Modification for:
Shallow ISUS and DuraFET Housing Endcap#2
to accept Subconn MCBH8M connector

Jannasch/MBARI; 4/12/14
Scale 1:1

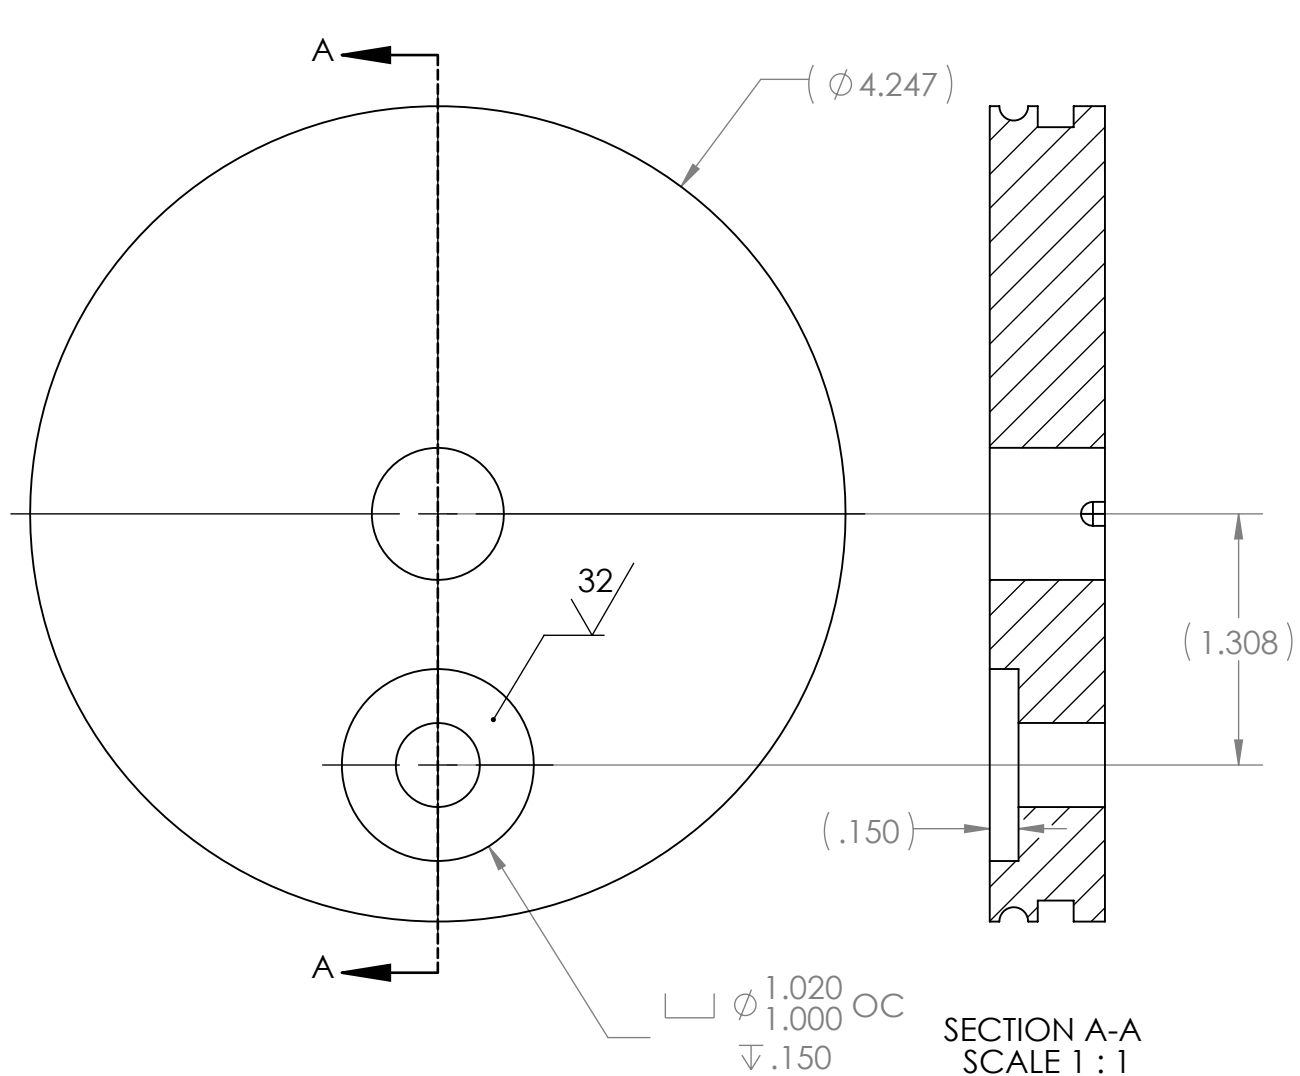
NOTE:
Use a thin washer under nut, ($<.040$ " thick)
e.g., MCM 98017A204
